ENVIRONMENT IMPACT ASSESSMENT NPP CERNAVODA 1 AND INTERIM WASTE STORAGE (ROMANIA)

*Refurbishment of npp Cernavoda 1 and Extension
of Intermediate Dry Spent Fuel Storage with
MACSTOR-400 Modules*

REPORT
REP-0930

Figure 1:
FlexRISK: example of the
effective adult dose
1 year

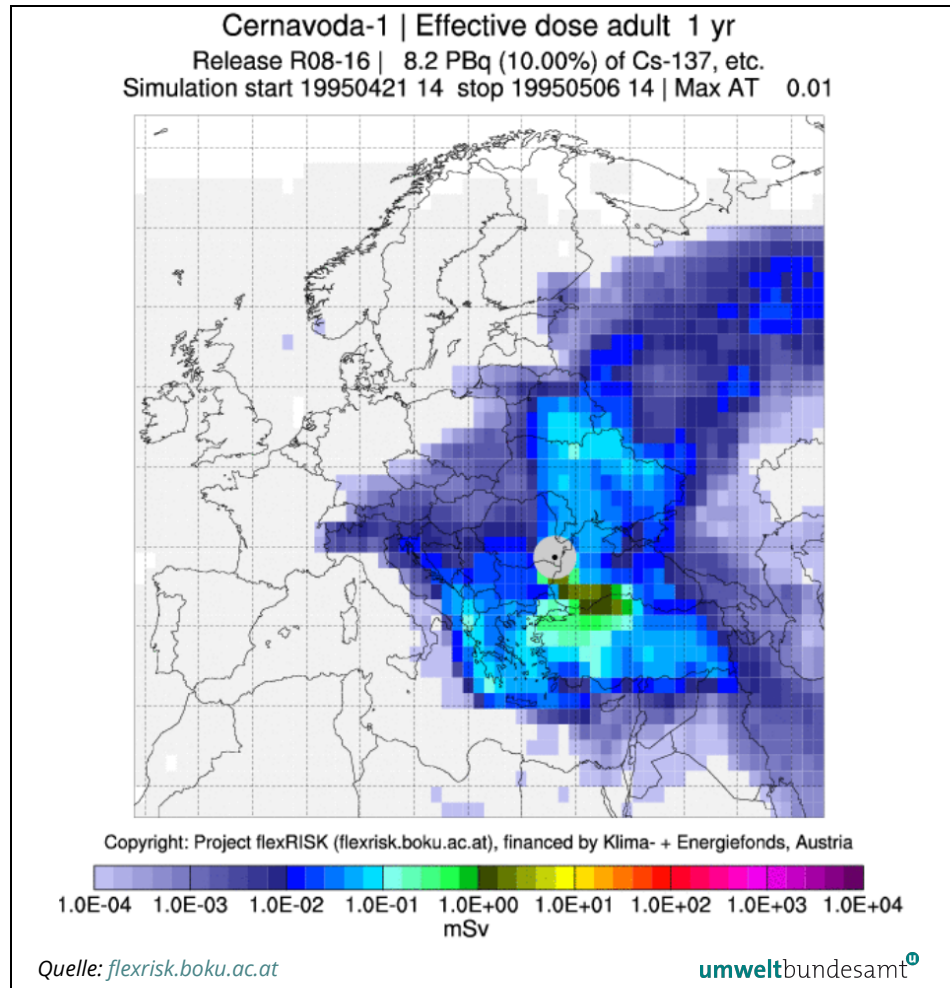
While this is not surprising – the maximum 1-y effective dose for an adult in Austria estimated by FlexRISK is 10 μSv – severe accidents and accidents affecting more than one nuclear installation at the site could result in higher doses.
